January 16, 2024

RE: Infrastructure Assessment Study for Sonoran Oasis Tech Park (aka Biscuit Flats

North)

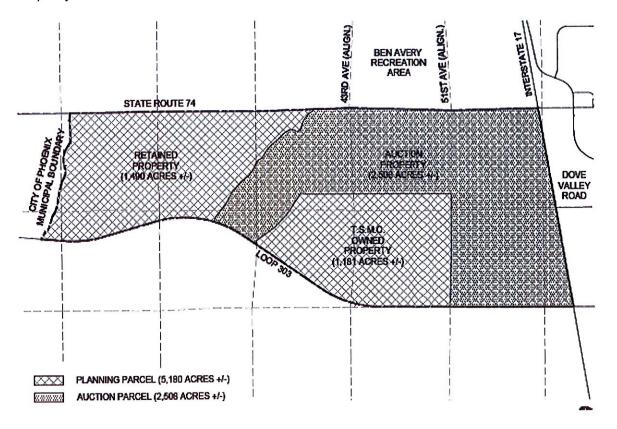
The auction and retained properties are depicted in the exhibit below and is generally described as ±3998 gross acres located between State Route 74 (Carefree Highway) and Loop 303 to the north and south and I-17 and the City's limits to the east and west. The requirements outlined in this letter only apply to the approximately 2,508-acre auction property shown below with a western boundary of Dead Man's Wash. ASLD has stated that a future infrastructure request letter will be sent for the Retained Property.

The following are Street Transportation Department (STD) comments on the Infrastructure Assessment Study (IAS) for Sonoran Oasis Tech Park, specifically the "Auction Property," as depicted on the RVI exhibit above and prepared for Arizona State Land Department and Biscuit Flats Dev LLC. The STD comments are general (high level) in nature and reflect only elements related to street infrastructure. Specific development proposals, along with required Traffic Impact Studies (including regional improvements), and Development PCD Master Plans will provide further clarity on specific required infrastructure improvements, phasing and financial contributions to area and/or regional Street improvements.

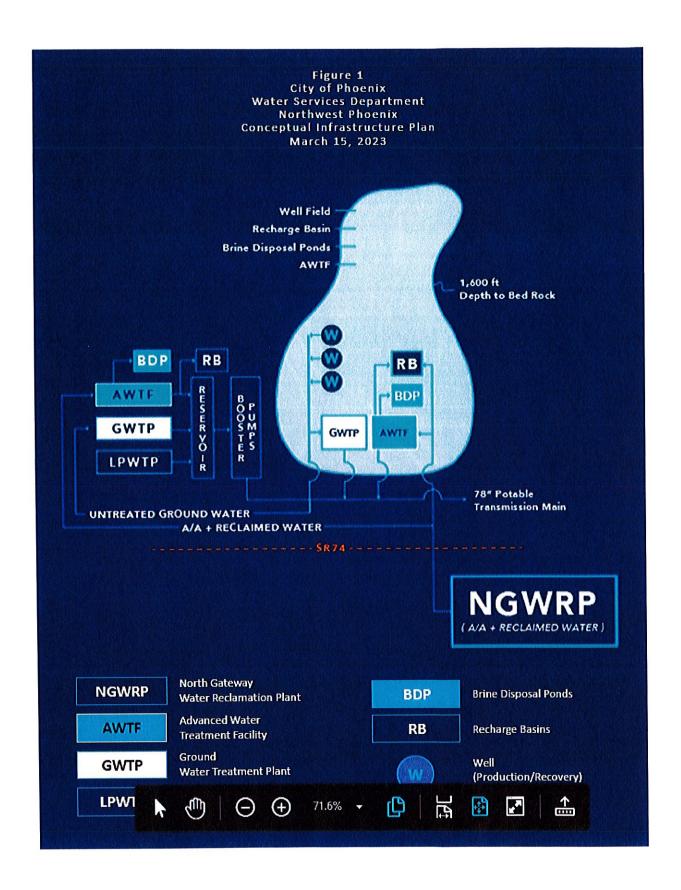
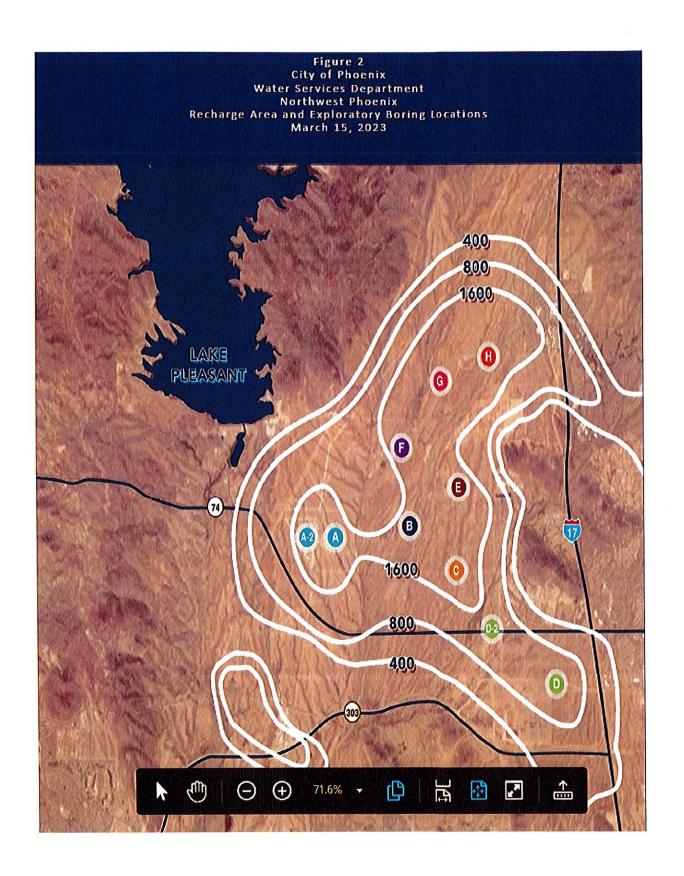
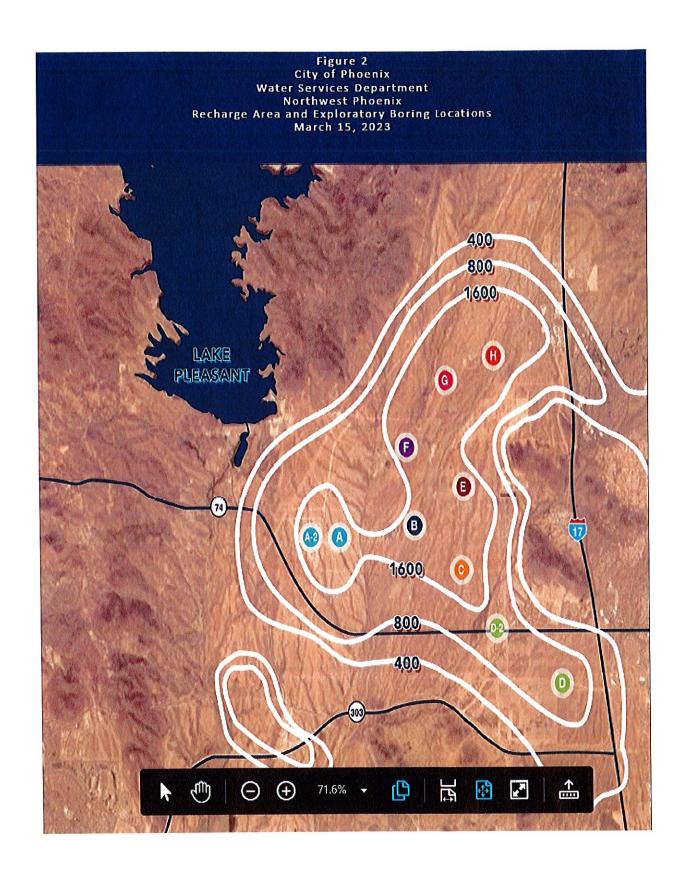
Figure 1 depicts the conceptual wastewater and potable reuse infrastructure plan for Northwest Phoenix, which includes Biscuit Flats. The Biscuit Flats area is generally subdivided into two planning areas. The first is generally referred to as the Biscuit Flats Residential and is approximately 6,300 acres bounded by the CAP Canal and the 303. The second area is the Sonoran Oasis Tech Park (a.k.a., Biscuit Flats Tech Park) which is approximately 2,500 acres bounded by the 303, SR 74, and Deadman's Wash on the west. Figure 2 shows the City's location to recharge reclaimed water generated at the North Gateway Water Reclamation Plant (NGWRP) and advanced purified water generated at the Advanced Water Treatment Facility (AWTF). The City will perform exploratory borings in the area to determine the best location(s) for recharge (e.g., basins, vadose zone wells, ASR wells) and recovery wells.

Below is a description of the facilities and infrastructure, depicted in Figure 1, to be used in the development of master plans for Northwest Phoenix and the proposed Sonoran Oasis Tech Park.

- 1. North Gateway Water Reclamation Plant (NGWRP). The NGWRP serves the entire northwest area of Phoenix. This includes the area north of the CAP canal and west of I-17 and a portion of the area on the eastside of I-17 to the City's northern border. The design of the plant will be similar to that of the Cave Creek WRP (CCWRP) with Biological Nutrient Removal (BNR), Membrane Bioreactor (MBR), and disinfection to produce A/A+ treated reclaimed water; construction of the CCWRP should begin 1QTR2024. Unlike the CCWRP, the NGWRP would be an end of the line plant and would therefore require onsite solids handling (e.g., solids reduction, dewatering, and drying beds). 100% of the reclaimed water will be pumped north of SR-74 to a recharge facility and Advanced Water Treatment Facility (AWTF). There will be no onsite recharge of reclaimed water at the NGWRP.

- 2. Advanced Water Treatment Facility (AWTF). The AWTF will be located north of SR-74. The final location of the AWTF is still yet to be determined. The AWTF could be located at the Lake Pleasant Water Treatment Plant (LPWTP), which could allow for the AWTF to use existing onsite reservoir(s) and booster pumps at the LPWTP. The AWTF could also be located near the recharge basins and the 78-inch potable transmission main; refer to Figure 1. As part of the master planning process the City will make the final decision on where to locate the AWTF. The design of the AWTF will be similar to that of the Cave Creek AWTF. The AWTF will also be an end of the line plant and therefore all solids must be handled onsite. This includes brine generated from the reverse osmosis (RO) membranes, which could require additional land.

- 3. Recharge and Recovery. The City has selected the area north of SR-74 for recharge and production/recovery wells (Figure 2, attached). Starting in 1QTR2024, the City will drill exploratory borings in the area to determine the best location for recharge (e.g., basins, vadose zone wells, ASR wells) and recovery wells.

- 4. Land Requirements and Easements. The land for the NGWRP is already owned by the City, but, is in its raw form; there are no onsite improvements. There is also a wash that runs through the property and it may require a 404 permit to perfect the site. The City owns the land at the LPWTP and it is anticipated that no additional land would be required to locate the AWTF at the LPWTP, however, additional land may be necessary for brine disposal and/or brine concentrators. If the brine ponds cannot be located at the LPWTP, then additional land would need to be provided to the City. Land for the recharge basins will also need to be provided to the City. Easements for the reclaimed water transmission main will also need to be provided to the City. Additionally, the City will require land for the production/recovery wells and possibly additional easement for the untreated well water transmission main from the well field to the
